Mobile Intel[®] Celeron[®] Processor at 466 MHz, 433 MHz, 400 MHz, 366 MHz, 333 MHz, 300 MHz, and 266 MHz Specification Update

Release Date: October 2002

Order Number: 244444-037

H29. Thermal Sensor May Assert SMBALERT# Incorrectly

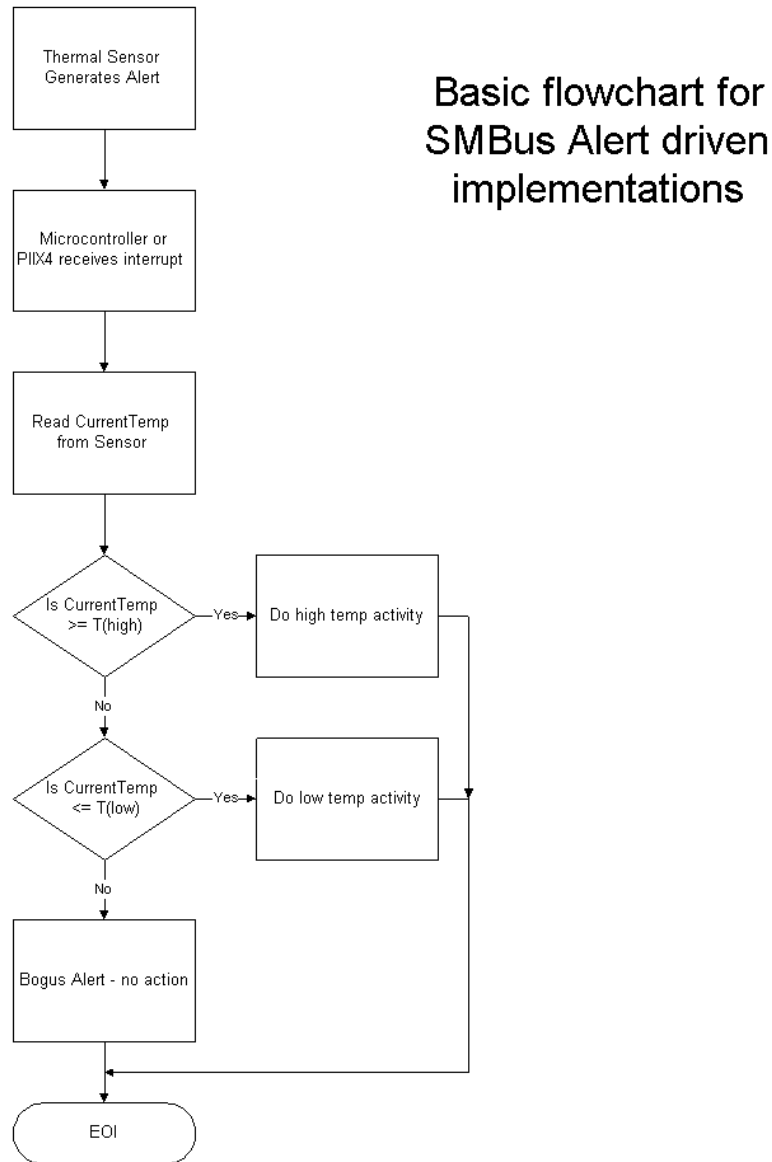
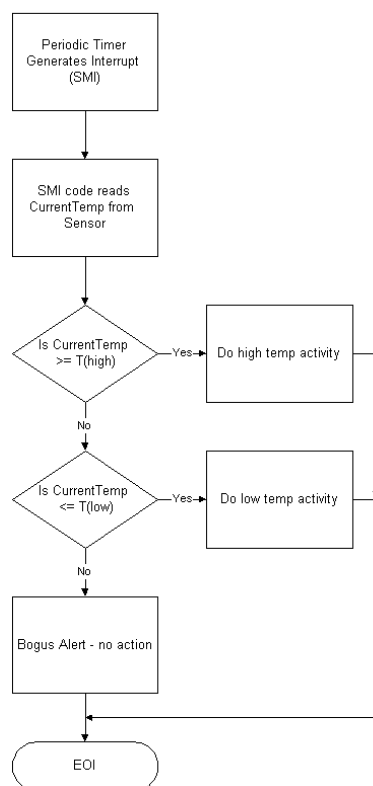
Problem: The Intel Celeron Processor Mobile Module has a thermal sensor that monitors the processor core's temperature. Please note that desktop systems could have a similar thermal device. The thermal sensor asserts SMBALERT# if the processor temperature exceeds the temperature limits set in the Alarm Threshold Registers (T_{HIGH}, T_{LOW}). It also sets the corresponding Status Register bits to identify the cause of the interrupt. Figure 1 gives one example of the how the SMBALERT# signal could be used in a system.

Implication: There is no system impact from this erratum if temperature polling is used for processor thermal management. If the SMABLER# interrupt is employed to manage processor thermal sensing, then servicing the false interrupt may result in premature system action depending on the software and hardware implementations used. The rate of the false interrupts is less than the auto-convert rate of the thermal sensor.

Workaround: Three different (mutually exclusive) workarounds are possible:

1. Before servicing an interrupt from the thermal sensor, read and compare the processor thermal reading with the threshold limits (T_{HIGH} or T_{LOW}). Figures 2 and 3 provide basic flowcharts for the implementation of this workaround in an interrupt driven system.
2. If the firmware implemented polls the Status Register only, then before taking any action, re-read the temperature register and do a comparison with the alarm threshold limits (T_{HIGH} or T_{LOW}) to determine if the value is actually still within the temperature window.
3. Use a temperature polling scheme to monitor the processor temperature.

Figure 2. Workaround Flowchart: SMBALERT#-Driven System

Figure 3. Workaround Flowchart: SMI#-Driven System
